The Corporation of the Township of Central Frontenac Committee of Adjustment Agenda

Tuesday, February 10, 2026 at 5:00 PM
Council Chambers, 14216 Road 38, Sharbot Lake, ON

- a. APPN-2025-0054 SMITH (MCKINNON) 9 - 52
[APPN-2025-0054 - Application](#) 
[APPN-2025-0054 - Sketch](#) 
[APPN-2025-0054 - Site Plan](#)

b. APPN-2024-0020 HUSSEY

Figure 1: Sketch submitted with the application showing the existing footprint (red area), new interior living space (blue area) and uncovered deck extension (yellow area).

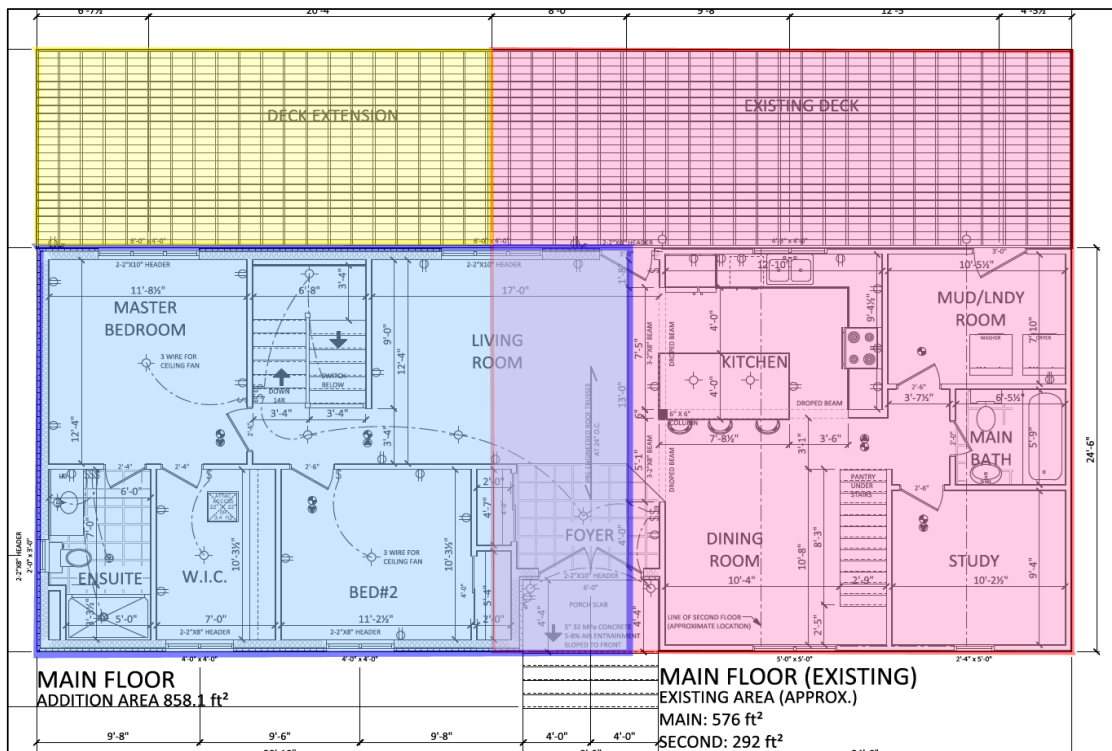
(858.1 square feet). This addition will reduce the setback to the edge of the wetland to a minimum of 18 metres (59.1 feet), measured to the attached deck.

There is an existing attached uncovered and unenclosed deck that wraps around two sides of the dwelling, 27.3 square metres (294 square feet) of this deck will be converted to interior living space. The addition will have a footprint of 79.7 square metres (858.1 square feet) for the dwelling structure portion and a footprint of 27.7 square metres (298 square feet) for the attached uncovered and unenclosed deck extension. This deck extension will have approximately the same area as the existing deck that will be converted into interior living space.

Figure 2: Sketch prepared by planning staff showing the existing and proposed development, the septic system area and the setbacks to the wetlands.

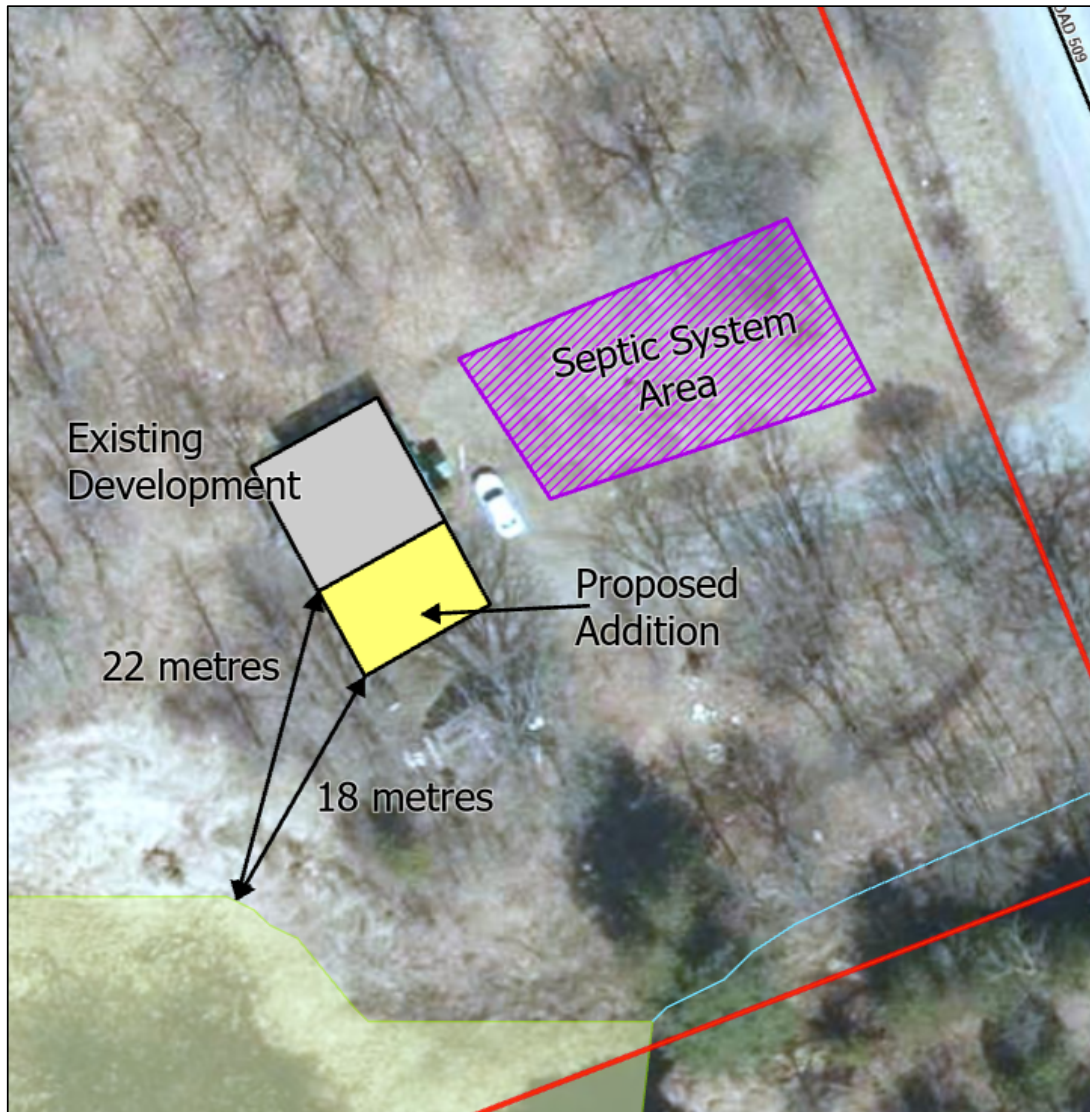
County planning staff do not anticipate any negative impact on the functioning of the wetlands as a result of this application.

County planning staff are of the opinion that this application is desirable for the appropriate development of the subject property. The proposed addition will increase the functionality of the dwelling for the owners and can be appropriately serviced with the existing on-site services.

PLAN of SURVEY of
 PART of LOT 5, CONCESSION 4
 Geographic Township of Kennebec
 Township of Central Frontenac
 COUNTY of FRONTENAC

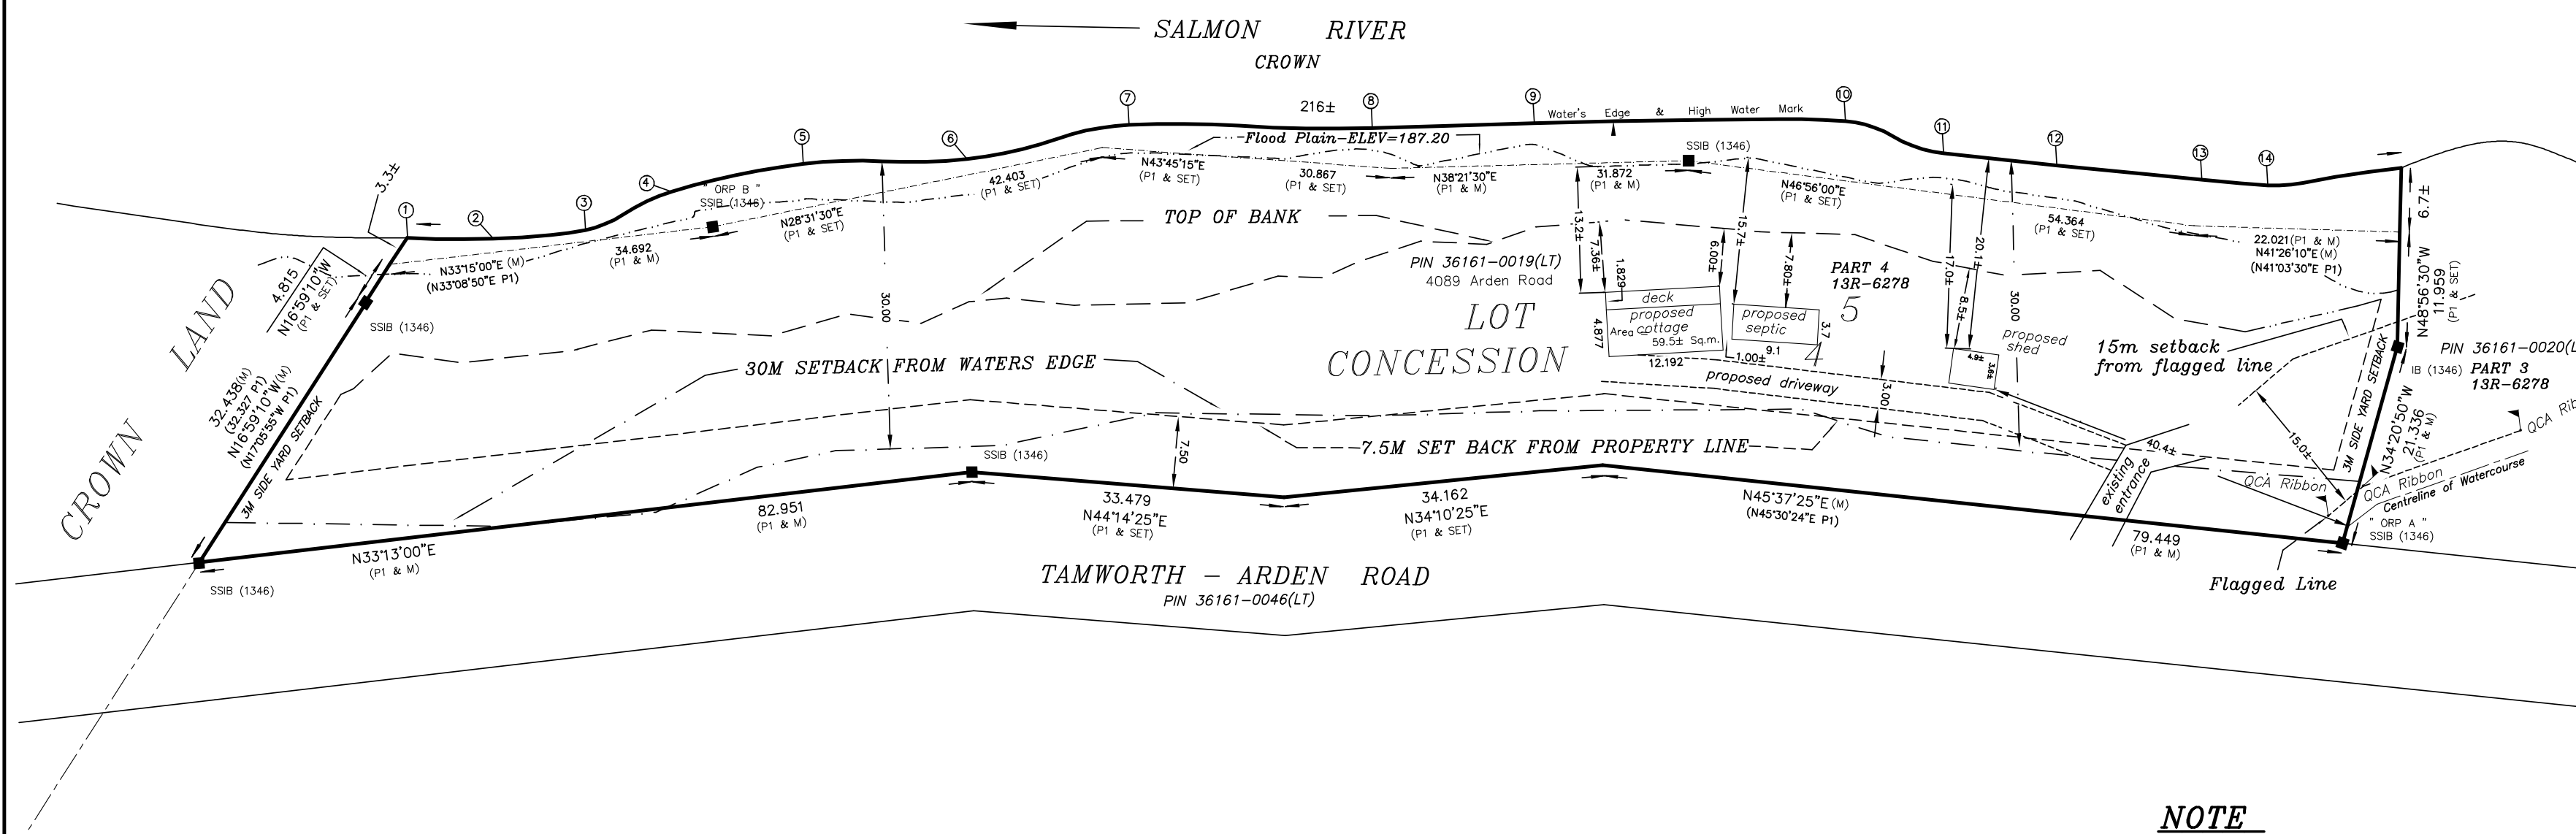
<p>Final Comments:</p>	<p>As per the Geotechnical Slope Assessment prepared by Concord Engineering, dated July 14, 2025, and the updated Plan of Survey received January 16, 2026 (attached), Quinte Conservation has <u>no objection</u> to the minor variance application as presented. The proposed development activities are consistent with Section 5.2 of the PPS, and Quinte Conservation watershed policies.</p> <p>Staff request that a copy of the decision on the application be forwarded to this office, when available.</p>

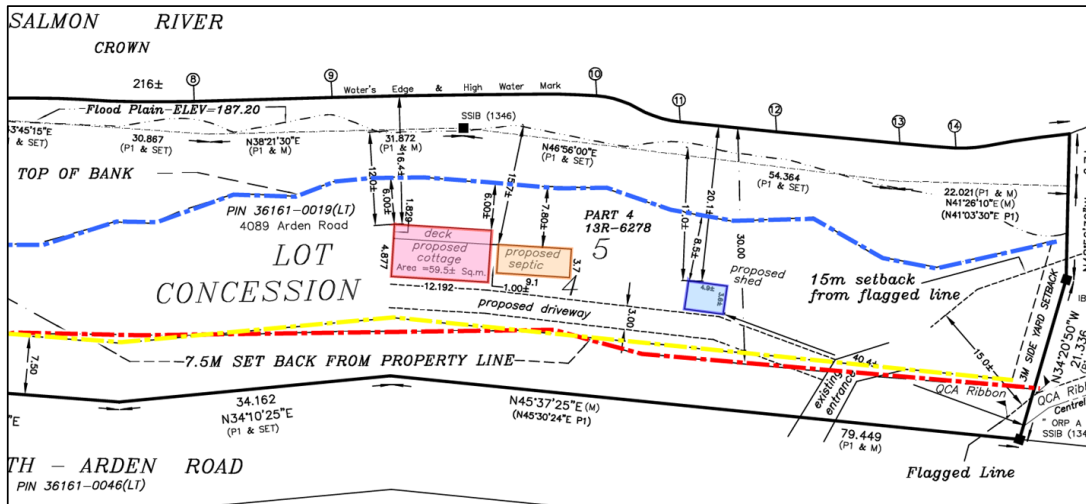
Based on the survey sketch submitted with the application the 30 metre (98.4 foot) waterbody setback overlaps with the required 7.5 metre (24.6 foot) front yard eliminating the possibility for development on the property without additional planning approval.

The proposed new dwelling will have a footprint of 59.5 square metres (640.5 square feet), plus a 23.63 square metre (254.5 square foot) attached uncovered and unenclosed deck on the water side of the dwelling. This structure will have a minimum waterbody setback of 16.4 metres (53.8 feet) to the high-water mark of Salmon River, measured to the edge of the attached deck.
